U.S. Department
of Transportation
**Federal Highway
Administration**

In Reply Refer To:
HSSD/WZ-284

In your letter of August 10, you requested the Federal Highway Administration (FHWA) acceptance of the Acme 3PS Type III barricade as a crashworthy traffic control device for use in work zones on the National Highway System (NHS). You requested acceptance of the barricade for use with aluminum laminate sign substrate material (up to 4 mil thick) and modified the generic design of the Type III barricade accepted by FHWA in letter WZ-85. The modifications include the use of 1/8 inch thick uprights and angle iron barricade feet shortened to 48 inches. These modifications are detailed in the attached drawing.

MODEL#	ACME 3PS	MANUFACTURER	ACME BARRICADES, L.C.
DRAWN BY	SCOTT CAMPBELL	PHONE #	904-781-1950
SHEET NUMBER	1 OF 1	DATE	7-30-09
TITLE	ACME 3PS

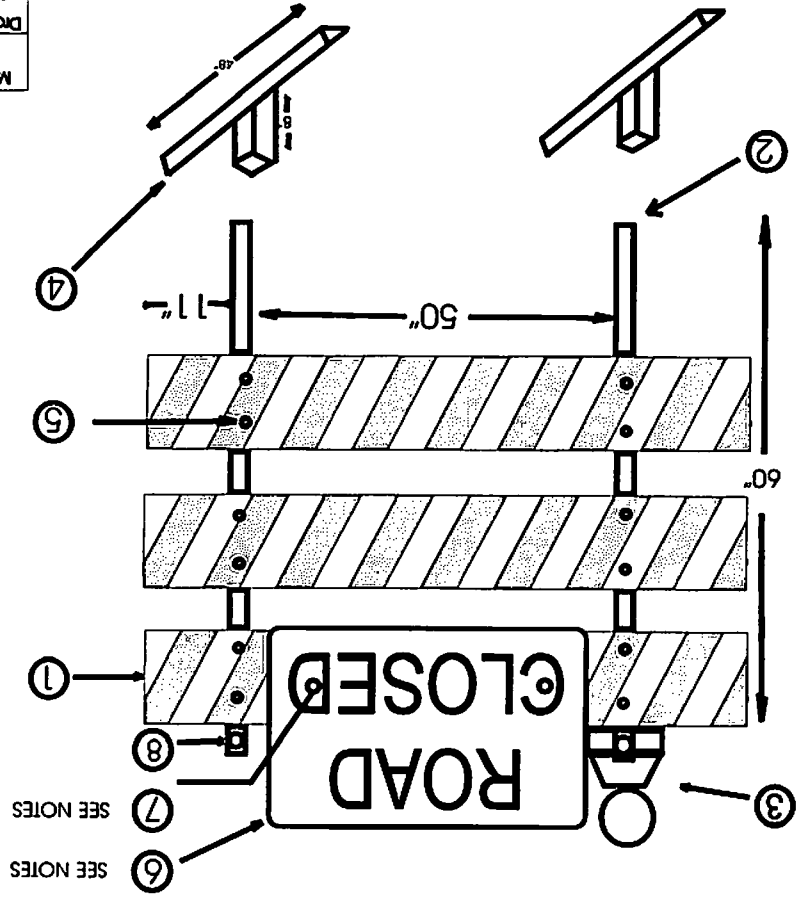
# of flags:	# of lights: 2 Weight of lights: 3.30 ea.
Device Name		
Detailed Desc. Of Device, Materials, sizes, Fasteners, Substrates Foundation, Aux. Features Ballast, etc.	(May be attached on separate page(s)) The Acme 3PS is a modification to the generic Type III barricade in WZ-85 and a combination of WZ-85 and WZ-100#3. The sign substrate is aluminum laminate with a thickness of less than or equal to 4 mil and mounted directly to the rails with the height of the bottom of the sign equal to or greater than 12 in. See drawing for details.

This letter acknowledges FHWA's acceptance of your request. The original completed forms have been modified by the addition of the FHWA acceptance letter number and the date of our review. The form will be posted on our Web site in the near future.
